Taxi and Regulatory Committee

Item No	Item	Pages
3.	TOWN AND COUNTRY PLANNING ACT 1990 – SECTION 257 PUBLIC PATH ORDER, FOOTPATH 61 (part) CALDICOT also known as FOOTPATH 7(part) CAERWENT.	1 - 14

Public Path Diversion Order 2025
Town & Country Planning Act 90, s257
Monmouthshire County Council
Footpath 61 (part), Caldicot
also known as
Footpath 7 (part), Caerwent

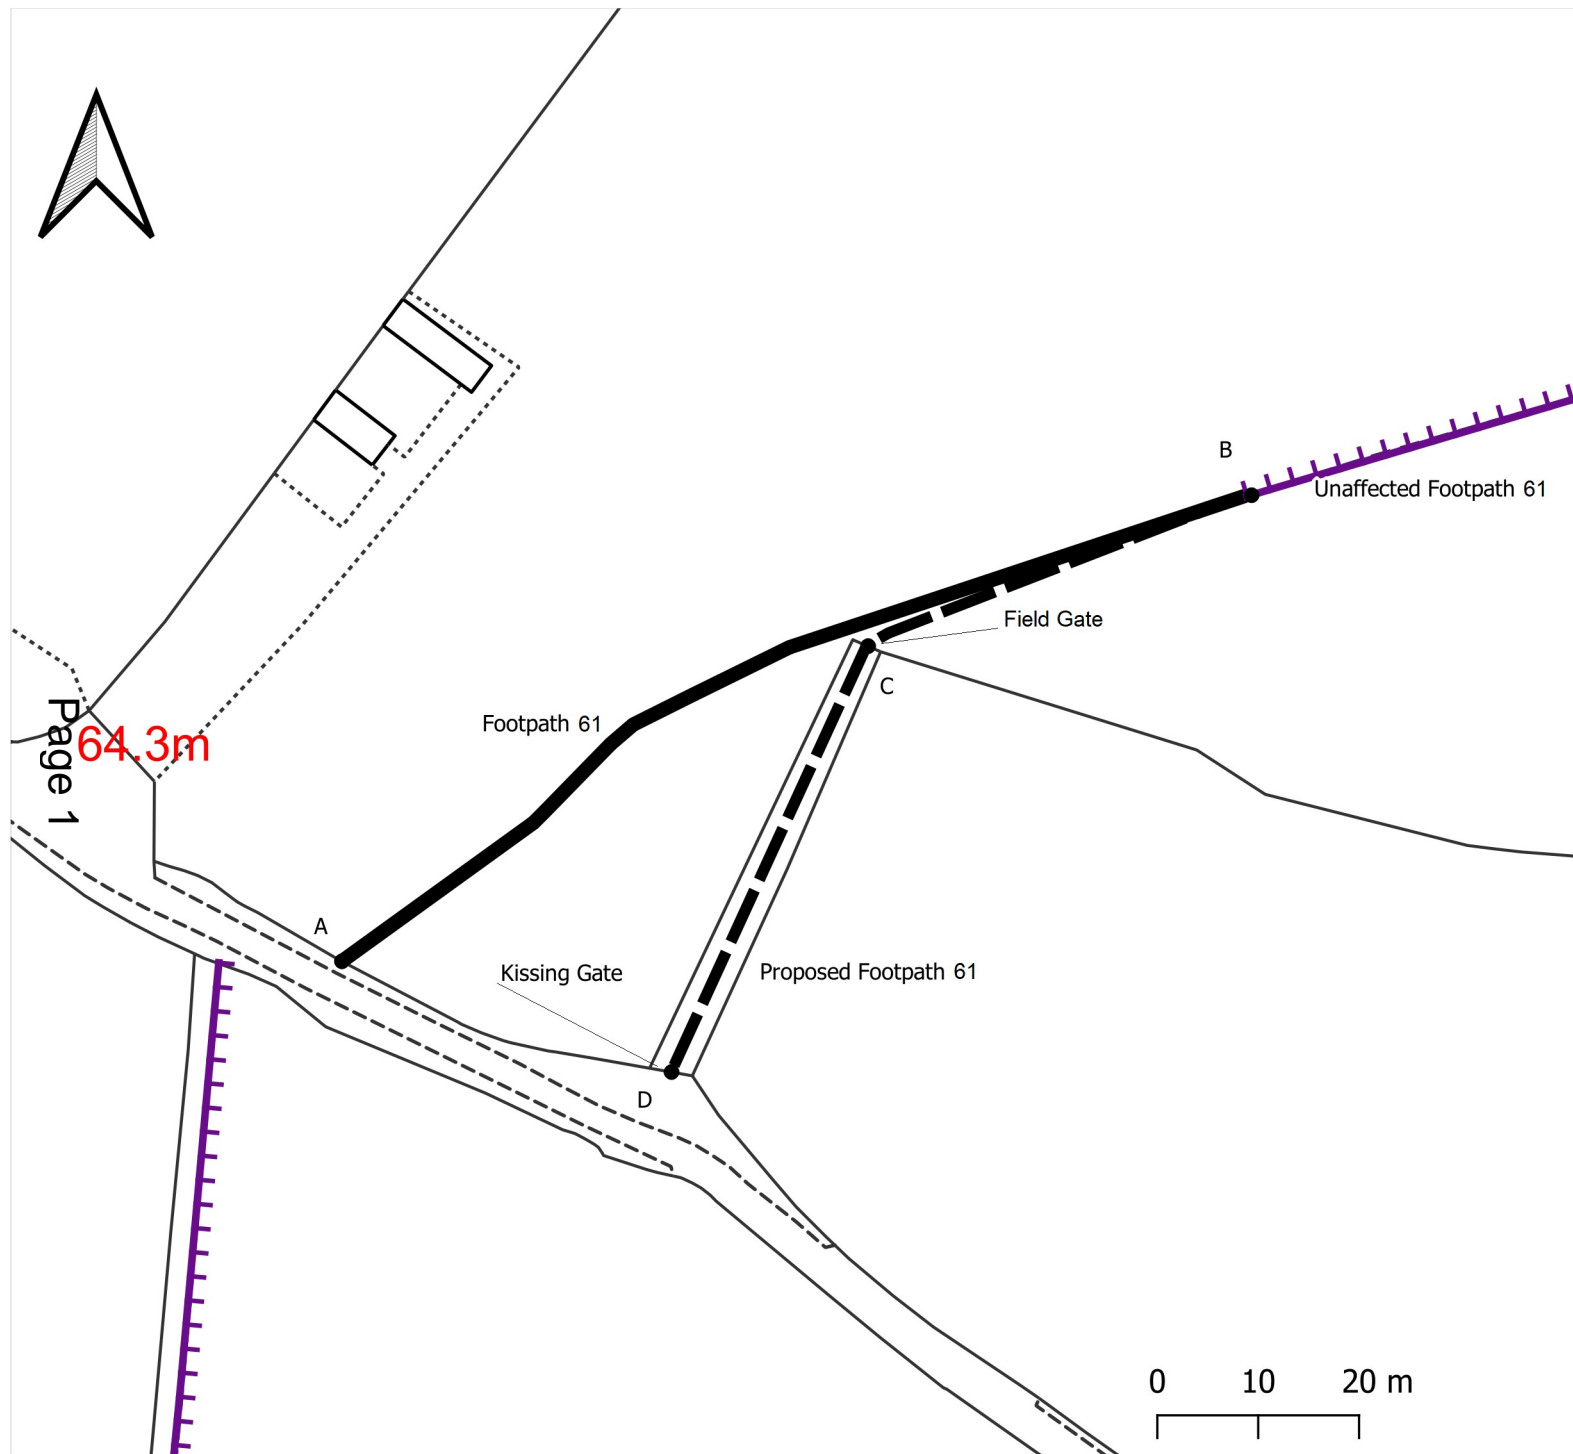
The landowner in this instant had already fenced in the proposed footpath D to C and had a field gate already in place at point C if by memory is correct.

The proposed footpath is 3 mtr wide and would be easier to maintain and less likely to be come overgrown.

The road at point D was slightly wider and therefore the exit via a kissing gate on to the road in my opinion would be safer than the current exit over a stile at point A.

Purely on the suitability of the proposed footpath diversion, I have no objection.

We therefore would recommend a 2 metre buffer zone along the eastern hedge be retained between the hedge and the footpath even after construction works are complete in order to protect nesting birds from disturbance each year.

I would like to strongly object to the proposed diversion of the existing footpath to align with the eastern boundary of the field, this will detract significantly from the public's experience of this right of way access. At present heading from Five Lanes towards the Rodge Wood/Rodge Farm direction the walker initially experiences a wide open expanse of flat countryside and woodland and as the walk progresses toward the Rodge Farm a wide open vista is revealed below with open rolling countryside, the flat floodplain of the River Nidd, the historic Roman Wall, the picturesque village of Caerwent and the former wartime armaments factory, which itself has 2 visible scheduled monuments slowly come in to view, a unique experience. If the footpath is rerouted as proposed the walker will be 'funnelled' through a high fenced corridor with a built development to the left side and thick deciduous hedge immediately to your right and as such there will exist no view. Unfortunately since March 2021 even though the footpath is currently in its original position the walker's experience is as follows: On arrival at the Five Lanes/Waterpits stile you are now greeted with intimidating signs of 'Dogs Running Free' and 'CCTV in operation', high solid wooden fencing immediately to your left and front, scanned by an array of CCTV cameras. This signage and material change has already made the experience of walking this path an intimidating one and is reducing the pleasurable experience of accessing this outdoor space, so vital to people's well being and enjoyment of the countryside.

The proposed area of the field that the path has been proposed to take has already been fenced off and prepared and contains 2 x gates across its access, a dog kennel and a makeshift wooden building with tarpaulin roof, is this an indicator of the poor accessibility that the walker will be confronted by if this diversion is approved? The proposal to align the new footpath with the deciduous hedge on the eastern boundary will also affect wildlife in this hedgerow, as it will force human and dog traffic in to close proximity to the hedgerow disturbing nesting birds, other mammals, insects and other invertebrates. Has this even been considered by the applicant?

Having viewed the area where the new stile is proposed to access the lane it is questionable whether the landowner making this application actually owns the land on which he is proposing to divert over, it appears to be outside of his boundary and crossing the neighbouring fields gated access.
